Stage 1/2 Road Safety Audit Report

Phase 3B Welborne, Fareham
Section 38 Works

Date: 10th April 2026

8. Audit Assessment

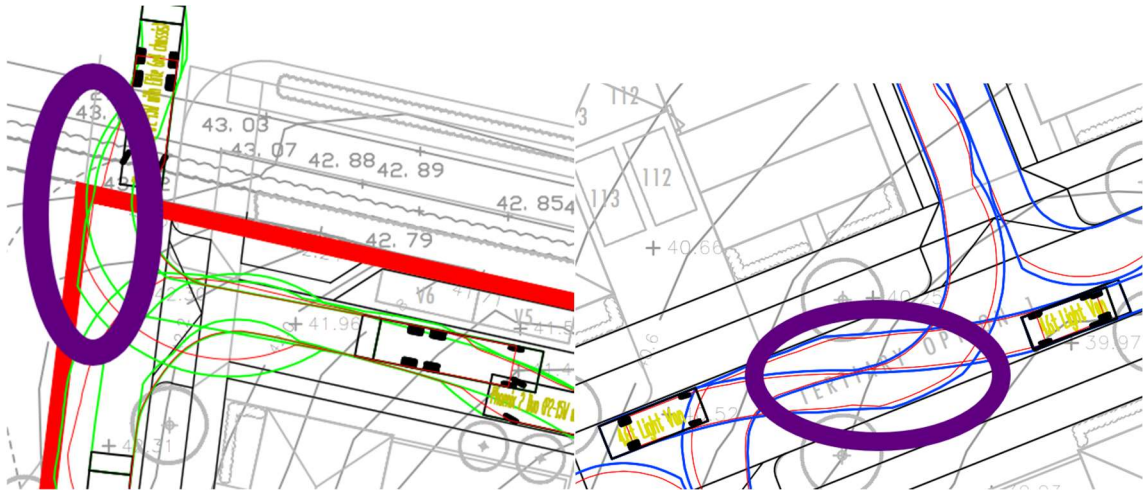
8.1 *Problem* (Item B1.5)	
Location:	Proposed carriageways and junctions.
Summary:	Manholes located in carriageway, in middle of junction /access, causing stability problems for turning two wheeled vehicles.
There are manholes / service covers detailed as being provided within the proposed junctions and bends in the carriageway alignments. These will cause problems for motorcycle/cycle stability when turning and need non-slip covers.	
TYPE OF CONFLICT/COLLISION	
Motorcycles / Cycles losing control while turning.	
RECOMMENDATION	
Provide non-slip covers where necessary.

8.2*Problem* (Item A1.12)	
Location:	General
Summary:	Swept path analysis indicates difficulty for larger vehicles
 Swept path analysis of the scheme using various vehicles has been supplied to the Audit Team. At a number of locations there are a number of locations throughout the proposals where vehicles are shown having to swing wide in advance of the junction to perform the turning manoeuvres. This may result in collisions or vehicles having to perform onerous reversing manoeuvres. Review the swept path analysis and amend the design where necessary to remove the onerous turning manoeuvres.	
TYPE OF CONFLICT/COLLISION	
Risk of collisions.	
RECOMMENDATION	
Review the swept path analysis and amend the design where necessary to remove the onerous turning manoeuvres.

8.3*Problem* (Item A3.1)	
Location:	Carriageway alignment at Plots 168/169
Summary:	Forward visibility not in land offered for adoption
There are two sharp bends detailed within the scheme. Forward visibility has been detailed at these bends. The visibility splays detailed pass beyond the area shown to be offered for adoption. This may result in the required visibility splays becoming obstructed, which may lead to head-on collisions at the bends. Ensure forward visibility splays fall over land to be offered for adoption where visibility can be maintained and meet current criteria. Amend design where required.	
TYPE OF CONFLICT/COLLISION	
Risk of head-on collisions due to reduced visibility.	
RECOMMENDATION	
Ensure forward visibility splays fall over land to be offered for adoption where visibility can be maintained and meet current criteria. Amend design where required.

8.4*Problem* (Item A4.2)	
Location:	General
Summary:	Pedestrian crossing points not detailed
There are a number of locations where pedestrians will wish to cross the various development roads. Pedestrian crossing points have not been detailed throughout the site. This may result in pedestrians having difficulty crossing the estate roads due to kerb heights, lack of guidance and insufficient visibility splays; particularly wheel chair users, push chair users and the visually impaired. Pedestrian crossing points should be provided at all likely desire lines, including suitable dropped kerbing, tactile paving and appropriate pedestrian visibility splays; these need to be provided free of obstructions and within land to be offered for adoption. Note: a drawing titled '<i>Phase 3B - Preliminary Pedestrian Visibility Plan</i>' was provided, however, it contained vehicle visibility splays not pedestrian splays.

8.5*Problem* (Item B4.2)	
Location:	Various pedestrian entry points to shared carriageways
Summary:	No tactile paving detailed at entry to shared space
There are a number of locations where pedestrians will enter shared space carriageways. Corduroy warning paving has not been detailed at these locations to warn pedestrians that they are entering a shared space. This may cause problems for pedestrians, particularly the visually impaired. Provide corduroy warning tactile paving at the entry to the shared space.	
TYPE OF CONFLICT/COLLISION	
Pedestrians unaware that they are entering a shared space carriageway.	
RECOMMENDATION	
Amend the design to provide corduroy warning tactile paving at the entry to the shared space.

8.6*Problem* (Item B4.2)	
Location:	Parking laybys
Summary:	Insufficient width of hardstanding
A number of parking laybys have been detailed within the scheme. Hardstanding has been detailed at these laybys, but the width has not been annotated. The widths appear narrower than the 1.2m width suggested for wheel chair users. This may result in pedestrians entering / leaving parked vehicles having issues and falling into the adjacent verges. Ensure a minimum of 1.2m width is provided at these hard standings.	
TYPE OF CONFLICT/COLLISION	
Wheel chair and push chair users having difficulty entering or leaving parked cars, falling into verge.	
RECOMMENDATION	
Ensure a minimum of 1.2m width is provided at these hard standings.

8.1	Manhole covers located on bends / in middle of road need non-slip covers.	Manholes to be fitted with non-slip covers cover	
8.2	Swept path analysis indicates difficulty for larger vehicles	Swept path analysis indicates that larger vehicles can successful navigate through the development within the extents of the carriageway.

8.3	Forward visibility not in land offered for adoption	Whilst forward visibility is shown within land not offered for adoption. The land will be subject to a covenant and will be under the control of Welborne Village Garden Trust. These areas will be kept clear of obstruction at all times.

8.4	Pedestrian crossing points not detailed	Pedestrian Crossing point indicated on the enclosed drawings.	
8.5	Tactile paving not detailed at entry to shared space	Corduroy paving indicated on the enclosed drawings.

8.6	Insufficient width of hardstanding at laybys	A 1.0m wide section of hardstanding has been provided to the rear of the parking bay to provide suitable access. The 1.0m footway represents a reasonable and proportionate compromise between pedestrian provision and the need to accommodate off-road parking. It provides a defined pedestrian route, improves separation between pedestrians and vehicles enables parking to be accommodated without increasing the extent of hardstanding or carriageway beyond the site boundary.	
-----	--	--	--
